Subject: AP1000 Responses to Requests for Additional Information (TR85)

Westinghouse is submitting responses to the NRC request for additional information (RAI) on AP1000 Standard Combined License Technical Report 85, APP-GW-GLR-044, "Nuclear Island Basemat and Foundation." These RAI responses are submitted in support of the AP1000 Design Certification Amendment Application (Docket No. 52-006). The information included in the responses is generic and is expected to apply to all COL applications referencing the AP1000 Design Certification and the AP1000 Design Certification Amendment Application.

AP1000 TECHNICAL REPORT REVIEW

Figure RAI-TR85-SEB1-027-01 Soil Reaction Forces on Section B-B

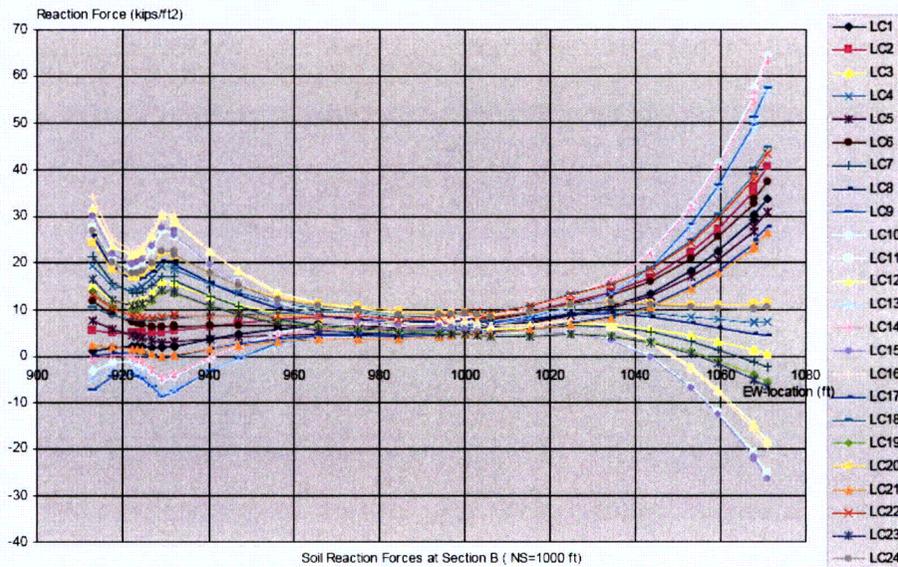
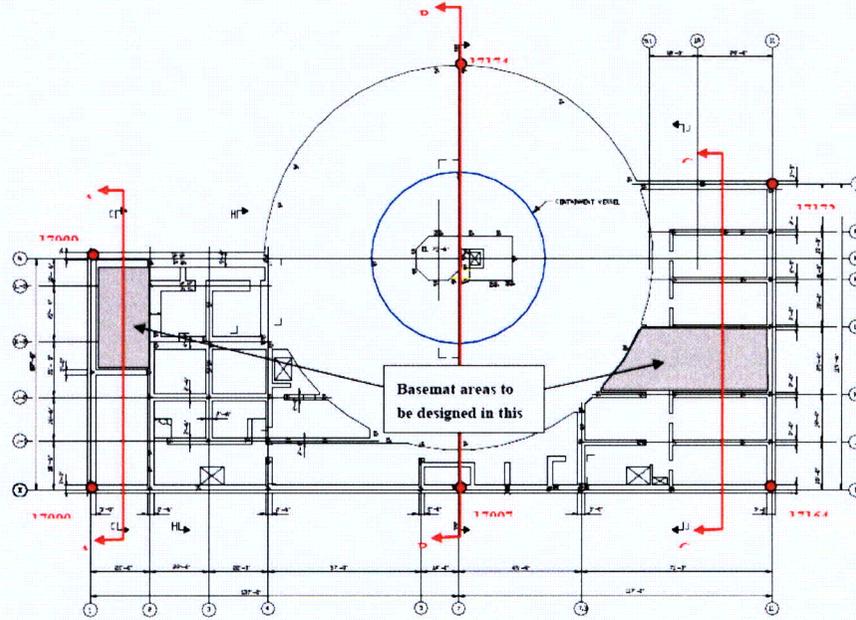
The response explains that the non-linear analyses were not performed for the cases with 1.0 applied in the vertical direction since the maximum bearing demand is due to overturning rather than vertical seismic. It is not evident that this would always be the case. Please explain.

The purpose of the calculation described in Section 2.6 is not to find the maximum bearing pressure under the basemat, but rather to design the entire basemat. Explain your confidence that at other locations away from the maximum bearing pressure location, the combination with 1.0 applied to the vertical direction may not govern (e.g., near the line of rotation where overturning contribution would be very small). The applicant is requested to consider the 100/40/40 combination method for considering the three earthquake directions as it was intended, and not to drop certain combinations based on a judgment that has not been justified.

Linear analyses were performed for all 24 cases of the 100/40/40 combination method in the initial hard rock analyses and used to select the 16 cases analyzed in subsequent non-linear analyses. Typical results are shown in Figure RAI-TR85-SEB1-027-01. The cases with unit load factor in the vertical direction are load cases 17 to 24. The following 16 cases for the 1.0, 0.4, 0.4 method were used. Non-linear analyses were not performed for the cases with 1.0 applied in the vertical direction since the maximum bearing and member force demand is due to overturning rather than vertical seismic.
